**DC2RVA TOWN OF ASHLAND/HANOVER COUNTY CAC  
AUGUST 2017 CORRESPONDENCE**

**From:** Stock, Emily (DRPT) [mailto:Emily.Stock@drpt.virginia.gov]  
**Sent:** Wednesday, August 23, 2017 5:33 PM  
**To:** Harksen, Frank W.  
**Cc:** Selleck, Randy (DRPT); DC2RVAdocumentcontrol  
**Subject:** RE: DC2RVA Rail - Hanover questions

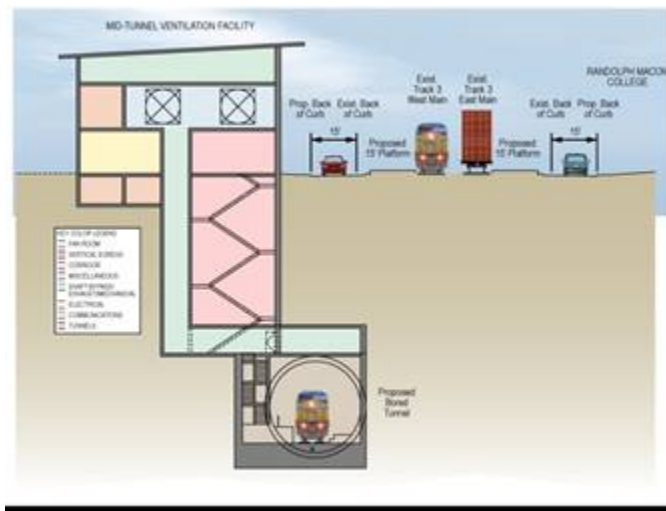
1. *Where are there examples of the kinds of ventilation buildings that would be needed and can photos be provided?*

The following graphic depicts the anticipated configuration and scale of the ventilation building required for either the deep bore tunnel option or soft earth tunnel option. DRPT expects that three ventilation buildings would be required, one near Vaughan Road/Archie Cannon Drive near the north tunnel portal, one near Ashcake Road near the south tunnel portal, and one at the center of the tunnel near England Street. The center ventilation building near England Street would be about 100-feet by 70-feet in size and 3-stories high. Below is an artist illustration to provide the CAC and the public with a concept of the building. DRPT is also preparing a surface-level rendering for the CAC.
